REMARKSDrawings

Serial No. 10/022,002

FIG-2C

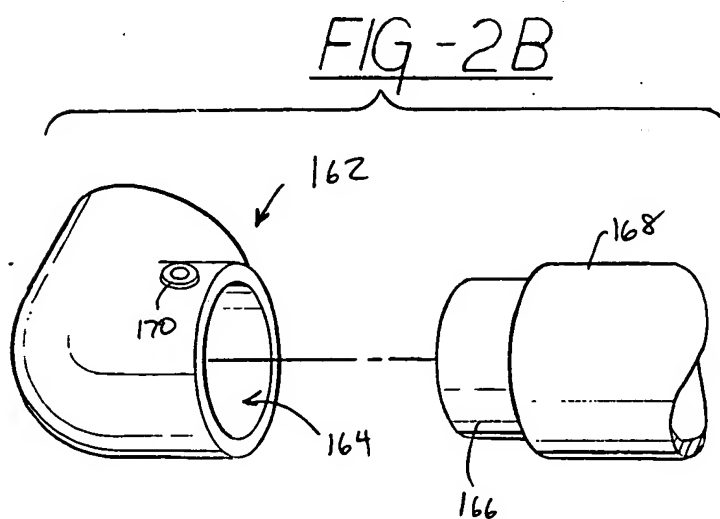
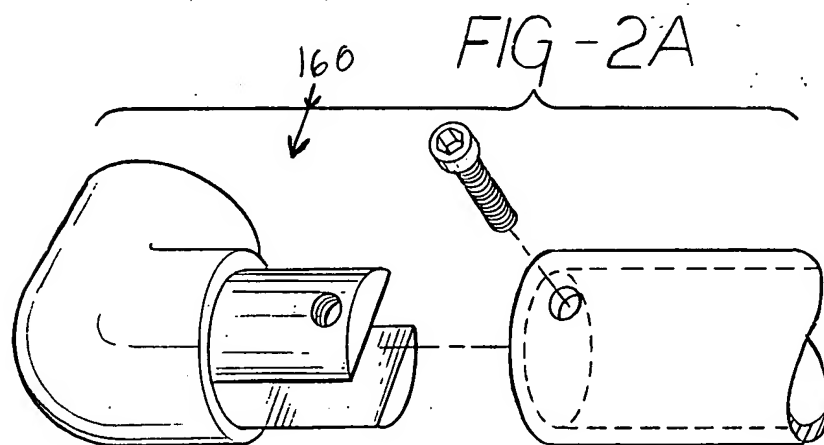
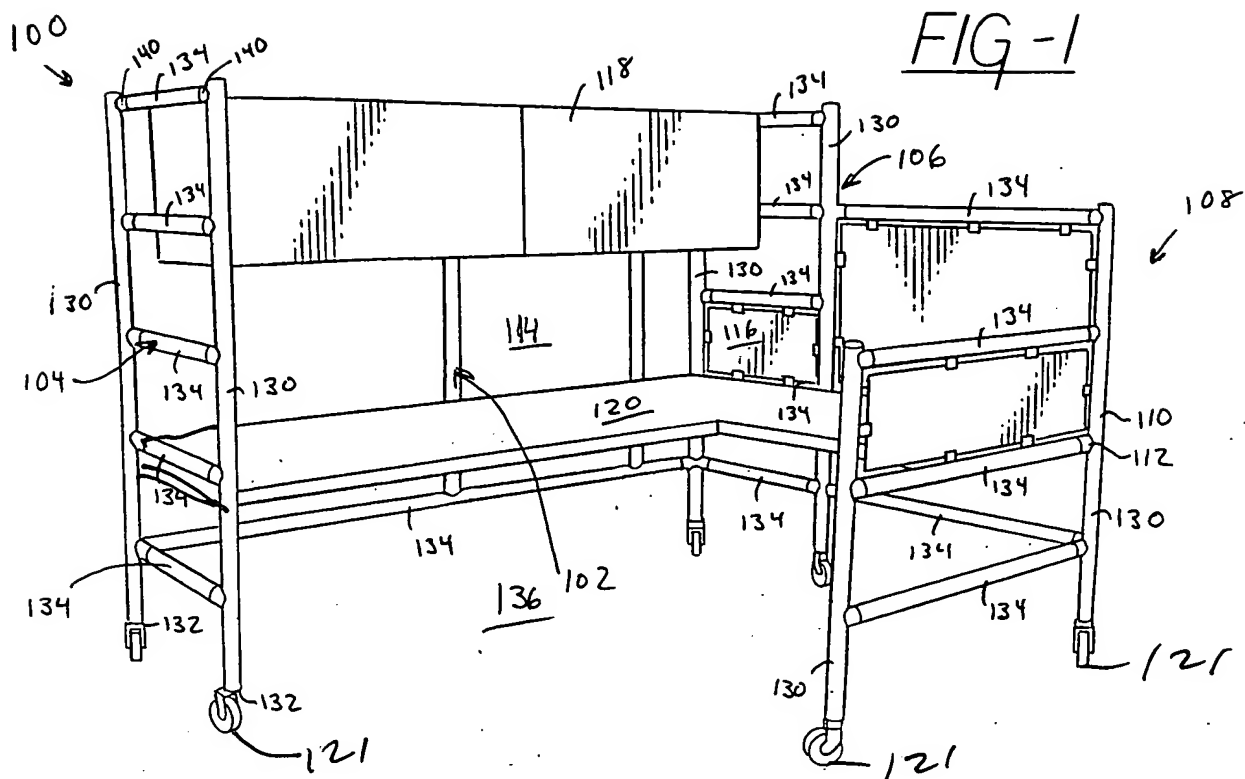
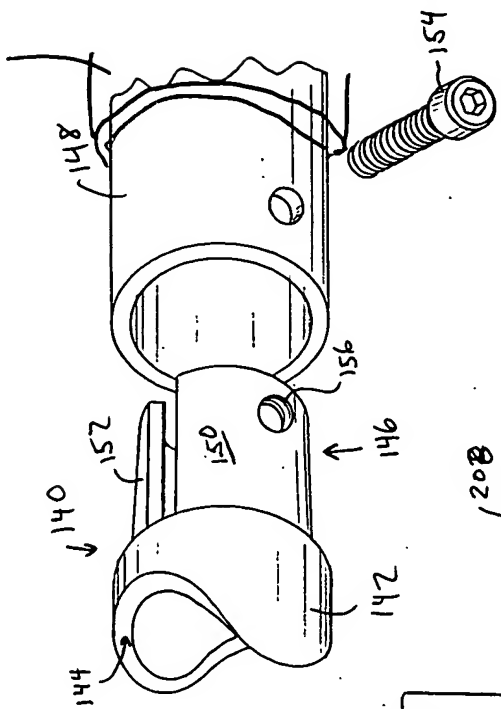
With regard to (c), Figure 2C has been amended, though Applicant feels such an amendment is entirely unnecessary.

Revised  
Drawing  
Correction  
approved  
6/27/03
